Reference: WX-2025-139536/02
LPA reference: PL/2025/09486

**Reserved Matters - for scale, layout, access, appearance, landscaping
following outline planning consent 20/00379/OUT**

LAND SOUTH OF TROWBRIDGE, SOUTHWICK, TROWBRIDGE

Snipped from FRA11 revB

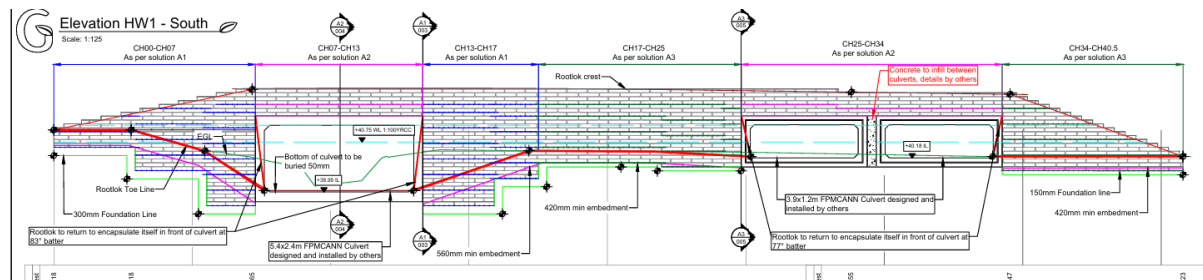
Drawing number FRA10 revB and FRA11 revB clearly secured, and specifically referenced in condition 11, show three openings in the bridge designs, one 20m wide across the Lambrok Stream and two 10m wide either side of the river.

Whilst the plans submitted for the outline application used the word ‘culvert openings’, due to the width of the opening over the main river being 20m, we didn’t raise any concerns however we now object to the culverting of the river as the width of the opening has been dramatically reduced to 5.4m. We considered that the opening was secured through our requested bridge designs and FRA condition specifying the 20m span.

The originally modelled bridge openings comprised one 20 m culvert and two 10 m culverts, which were confirmed as appropriate for managing flood risk. The current proposal significantly reduces this provision to two culverts of 3.9 m × 1.2 m and one culvert of 5.4 m × 2.4 m. Such a reduction in capacity is likely to impede flow, resulting in on-site water backing up and an increase in flood risk, which is contrary to National Planning Policy Framework (NPPF) requirement to avoid increasing flood risk elsewhere.

Updated hydraulic modelling is therefore required to inform an updated FRA which demonstrates that the revised culvert design will not increase flood risk on site or to surrounding areas before further comments can be provided. An updated FRA will also be needed incorporating the results from the modelling demonstrating that the proposed development will not increase flood risk on the site or any third party land.
